MEMO

From: Cambridge Transit Advisory Committee

**Re: Mount Auburn Street Corridor Study**

Map of location-specific comments from the Committee, described above

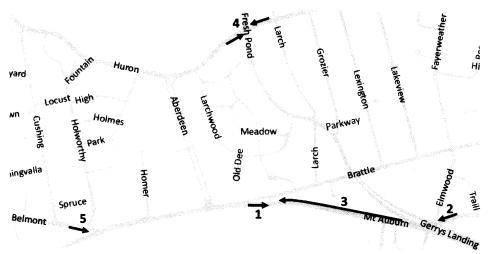
- 1) Converting the Mt Auburn Street and Brattle Street intersection to a signalized intersection could result in additional delay due to queueing. One potential solution, if a signalized intersection is indeed warranted, would be to provide a queue jump lane (at least eastbound but preferably in both directions) and Transit Signal Priority for buses. We ask that the study team assess the impact to buses.

- 2) Reducing the number of travel lanes at the Mt Auburn Street approach to Fresh Pond Parkway in the westbound direction. Currently, there are two lanes approaching this intersection, and buses tend to use the right lane as an informal queue jump. If this approach is reduced to one lane, buses will be forced to wait in the remaining singlelane queue. Perhaps a formal queue jump lane could be established.

- 3) Although we strongly support adding an eastbound bus only lane on Mt Auburn Street between Brattle Street and Coolidge Avenue, it will be important to ensure that, if a westbound travel lane is removed, delay to westbound buses does not outweigh the benefits to eastbound buses.

- 4) The intersection with Fresh Pond Parkway is a source of delay for buses traveling along Huron Avenue. Queue jumps at both Huron Avenue approaches should be considered. In the westbound direction, the queue jump could begin at the Huron Avenue at Larch Road bus stop.
- 5) We support the team's consideration of making the right lane on Belmont Street approaching Mt Auburn Street eastbound, into a queue jump for buses. The team could consider banning right turns (instead of continuing to permit them) since there are other opportunities to connect from Belmont Street to Mt Auburn Street.
